Office Action Summary

10/672,181

STEIGER ET AL.

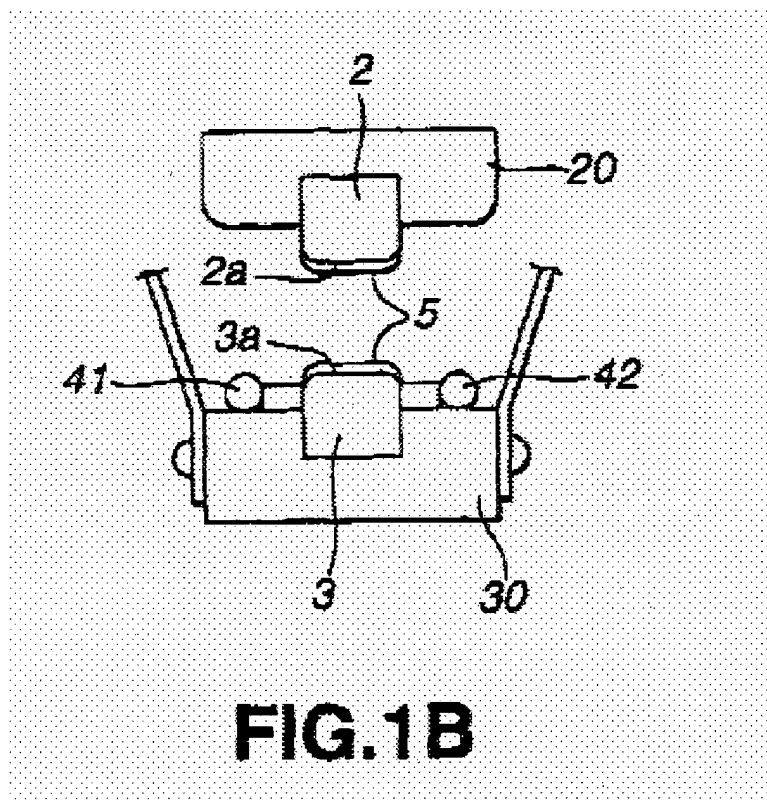
Hori et al illustrates in figure 1B a gas discharge laser having Fluorine gas, column 13 lines 16-20 and having a pair of discharge electrodes (2) and (3) [applicant's lower portion], where each electrode includes a film (5) [applicant's upper curve region] disposed on the discharge parts (2a) and 3(a) [applicant's footprint]. Column 19 lines 11-12, describes the film (5) as an insulator and in column 19 lines 43-46 discloses the film as a halogen-resistant substance made of copper fluoride [applicant's comprising copper]. In column 19 lines 17-24 Hori discloses, different metals used for the main discharge electrodes, which includes brass [where brass has benefit of applicant's CIP].

However, Ujzdowski et al discloses in column 7 lines 25-29, the use of aluminum bronze as the electrode [applicant's copper alloy].

Therefore, it would have been obvious to a person of ordinary skill in the art at the time of the invention to replace the electrode Ujzdowski et al with the electrode of Hori et al because it is more resistant to fluoride attacks than brass, column 7 lines 25-29 of Ujzdowski et al.
